UNITED STATES PATENT AND TRADEMARK OFFICE

APPLICATION NO.	FILING DATE	FIRST NAMED INVENTOR	ATTORNEY DOCKET NO.	CONFIRMATION NO.
09/653,527	08/31/2000	Vladimir Berezin	08305/078001/99-23	4646

Office Action Summary

11. The following figure includes the labels that will be used in the Kuroda rejection under 35 U.S.C. 102(e):

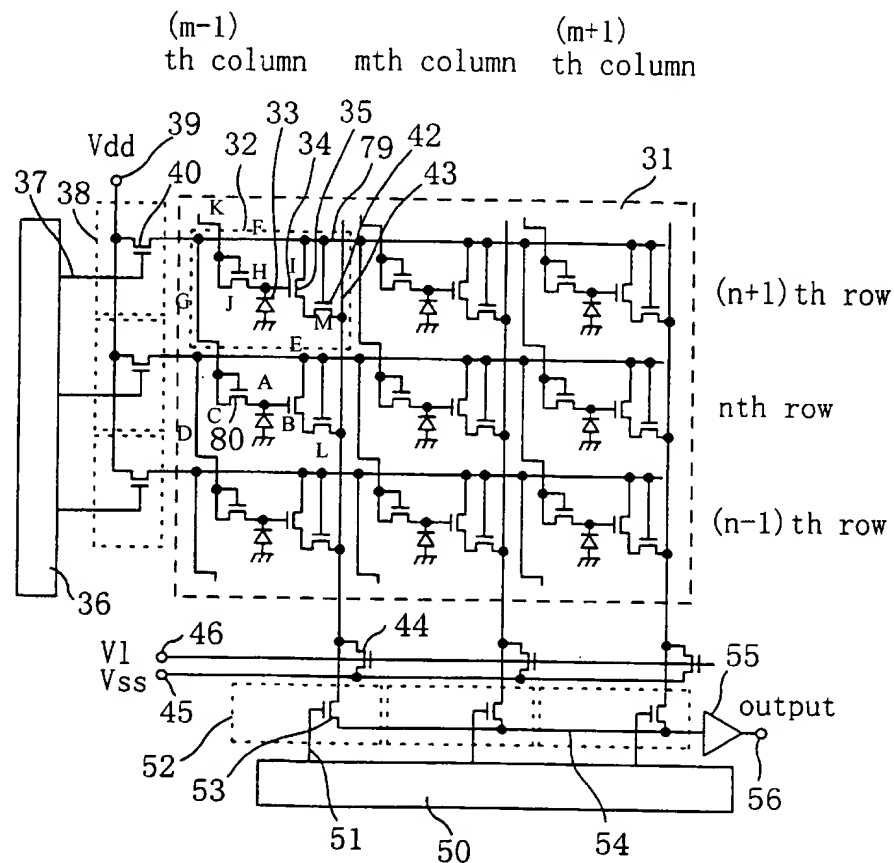
12. Claims 22-28 are rejected under 35 U.S.C. 102(e) as being anticipated by Kuroda (U.S. Patent No. 6,512,543).

Regarding **claim 22**, Kuroda discloses an image sensor, comprising:

a first pixel (D), said first pixel comprising a first photoreceptor (A), a first follower transistor (B; see column 6, lines 57-58) having a gate connected to said first photoreceptor, a drain of said first follower transistor connected to a first line (E), and a first reset transistor (C; see column 9, lines 19-20), a drain of said first reset transistor connected to a second line (F); and

a second pixel (G), said second pixel comprising a second photoreceptor (H), a second follower transistor (I) having a gate connected to said second photoreceptor, a drain of said second follower transistor connected to said second line (F), and a second reset transistor (J), a drain of said second reset transistor connected to a third line (K).

a third pixel (the above figure can have more pixels than those shown; see column 9, lines 15-24), said third pixel comprising a third photoreceptor (corresponding to H in an unshown pixel above pixel G), a third follower transistor (corresponding to I) having a gate connected to said third photoreceptor, a drain of said third follower transistor connected to said third line (K), and a third reset transistor (corresponding to J), a drain of said third reset transistor connected to another line (corresponding to K).

said first pixel further comprises a first select transistor (L) connected to said first follower transistor, said second pixel further comprises a second select transistor (M) connected to said second follower transistor.

said second select transistor and said first reset transistor each have a gate connected to a first reset/select line (F).

a gate of said first selected transistor is connected to a second reset/select line (E).

a gate of said second reset transistor is connected to a third reset/select line (K).
